SERVICE BULLETIN

M-1225A

2007/2008 CVO 110 C.I. DISPLACEMENT ENGINE UPDATE PRODUCT PROGRAM 0905

The purpose of this revision is to provide an option for those customers who choose to not have their original cylinder heads replaced with the cylinder heads included in kits 94675 and 94676

Figure 1. Crankcase Bolt

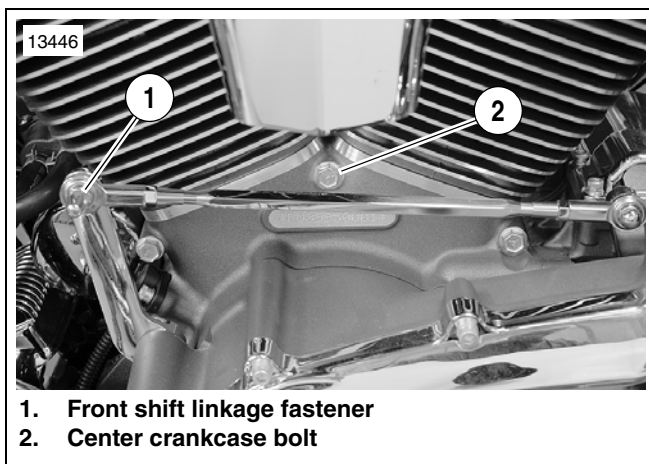
4. Assemble engine in reverse of disassembly. Refer to the appropriate service manual or supplement for proper assembly procedures and specifications.
5. See Figure 1. Replace the crankcase bolt using part number 1090A supplied.
 - a. Remove front shift linkage fastener (1) to gain access to the crankcase bolt (2).
 - b. Remove bolt (2) and replace with **new** one supplied. Tighten to 15-19 ft-lbs (20.3-25.8 Nm).
 - c. Install linkage fastener and tighten to 70-90 in-lbs (7.9-10.2 Nm).
